GE Hitachi Nuclear Energy

MFN 08-322

Docket No. 52-010

Subject: Consolidated RAI Responses and DCD Appendix 3L Revisions Related to ESBWR Steam Dryer

Figure 3L-1. Typical Chimney ~~and Partition~~ Assembly

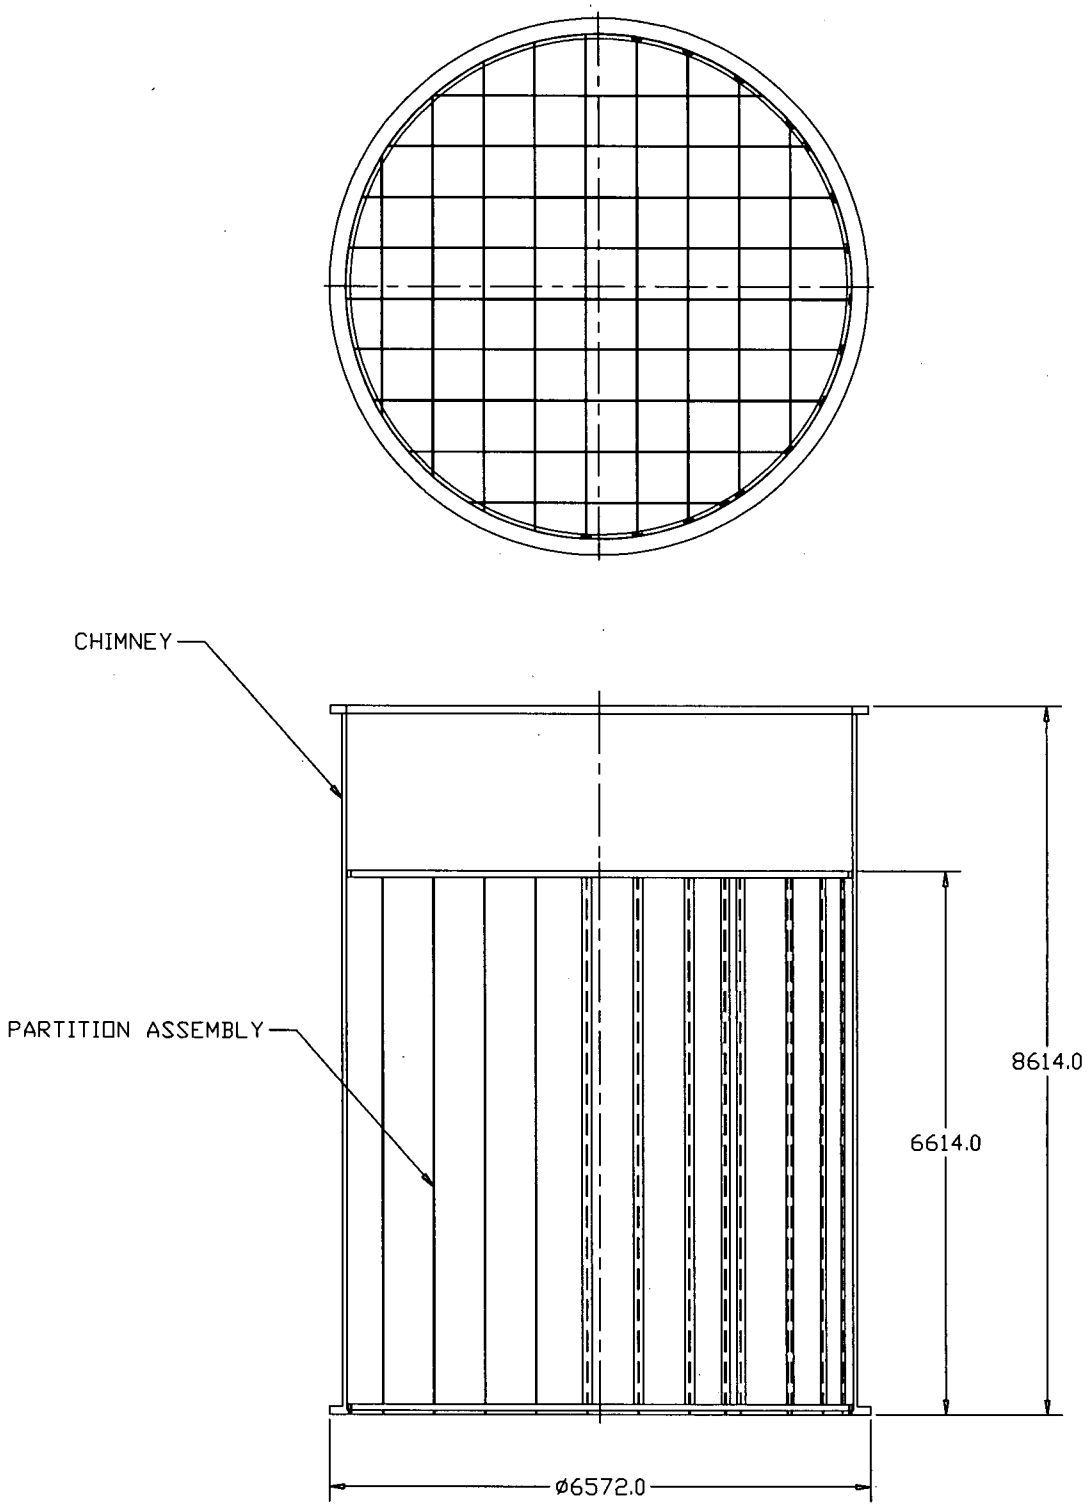
The chimney ~~partition~~ assembly design consists of a chimney shell and partition assembly. The chimney shell has a bottom ring ~~of the partition assembly~~ that rests on and is bolted ~~and pinned~~ to the top guide, see Figure 3.9-8. The chimney partitions rest on the bottom flange of the chimney shell. The top ~~ring~~ of the partition assembly is supported against the inside of the chimney shell. The ~~partitions~~partition assembly is ~~are~~ a grid of square structures, each of which encompasses and lines up with 4 top guide fuel cells (i.e.,16 fuel assemblies). The chimney shell and partitions are fabricated using austenitic stainless steel plate, see Table 4.5-1. The partitions ~~that is~~are full length welded ~~at~~ near the junctions of the partitions. ~~The austenitic stainless steel material has a 0.02% maximum carbon content to resist Intergranular Stress Corrosion Cracking (IGSCC).~~ The chimney ~~structure~~ shell that houses the partition structure is cylindrical, similar to the core shroud. A sketch of the chimney ~~and partition~~ assembly is shown in Figure 3L-1. Because the chimney shell has structural characteristics similar to the shroud, this component is considered under the generic reactor internals vibration program, and the partition assembly is considered to be the unique component that requires special vibration consideration.

Figure 3L-2. Typical~~ESBWR~~ Steam Dryer Assembly

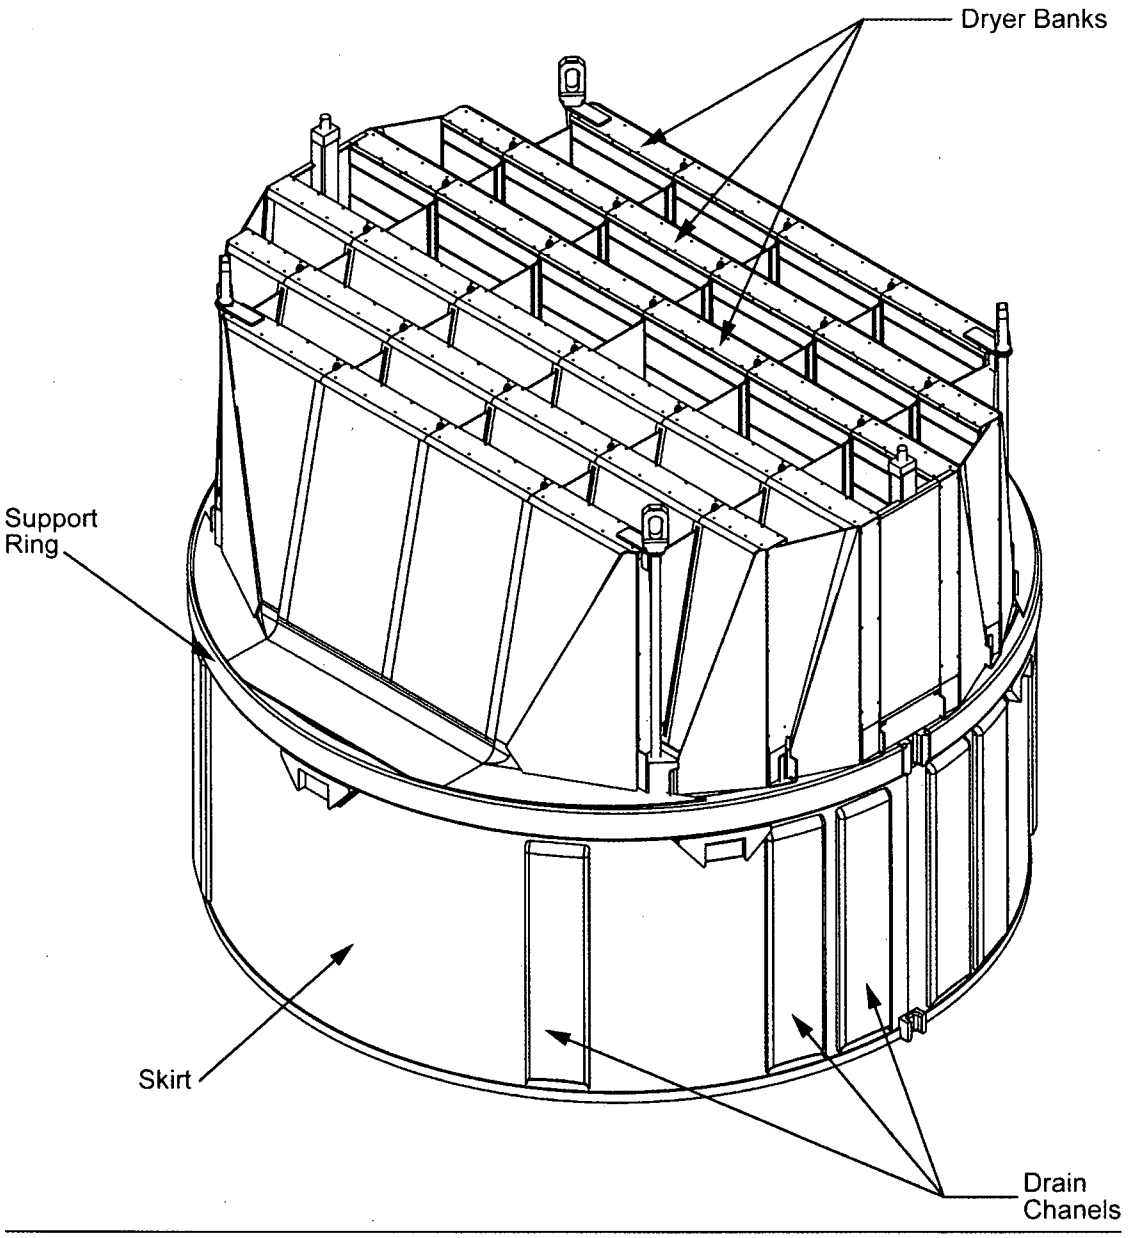
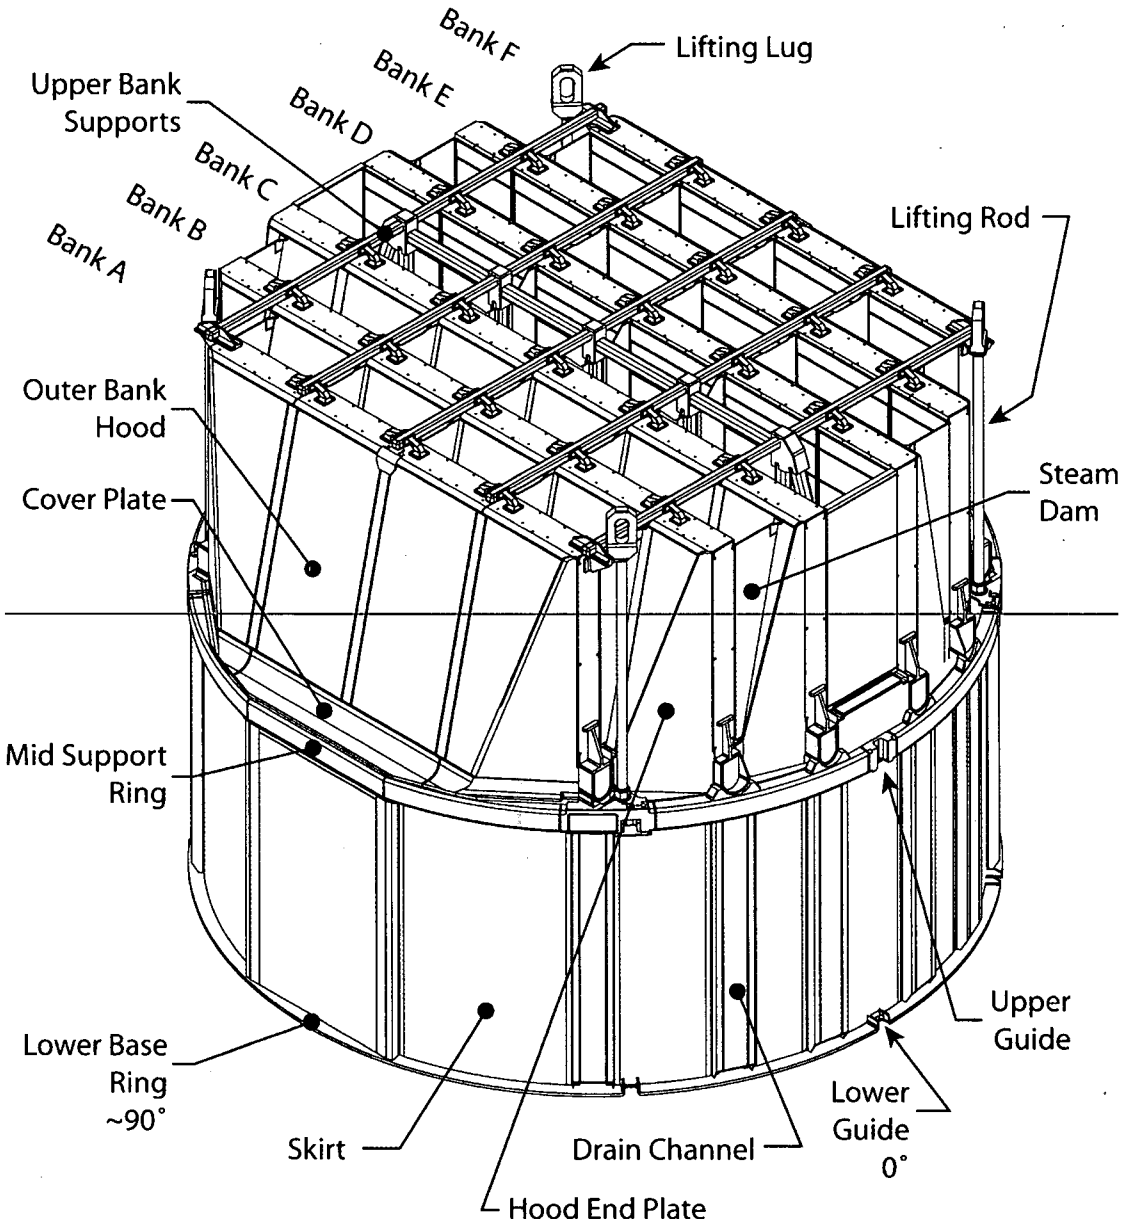
The ESBWR steam dryer consists of a center support ring with dryer banks on top and a skirt below. ~~is designed using modules of dryer vanes enclosed in a housing to make up the steam dryer assembly.~~A typical steam dryer is shown in Figure 3L-2. The ~~modules or subassemblies of dryer vanes, called~~ dryer units, made up of steam drying vanes and perforated plates, are arranged in six parallel rows called dryer banks. The ESBWR steam flow rate is approximately 15% higher than ABWR. The ESBWR RPV has a larger inner diameter at the vessel flange than ABWR, which will allow dryer banks to be extended, thereby accommodating the higher steam flow. The additional dryer unit face area will result in approximately the same flow velocity through the drying vanes as ABWR and help maintain moisture removal performance requirements. The ~~dryer banks are attached to an upper~~ support ring~~, which~~ is supported by RPV ~~steam dryer~~ support brackets.~~ that are welded attachments to the reactor pressure vessel (RPV).~~ The steam dryer assembly does not physically connect to the ~~shroud~~ chimney head and steam separator assembly.~~ and does not have a direct connection with the core support or shroud.~~ ~~A~~ The cylindrical skirt attaches to the ~~upper~~ support ring and ~~will~~ projects downward to form a water seal around the array of steam separators. Normal operating water level is approximately mid-height on the steam dryer skirt.
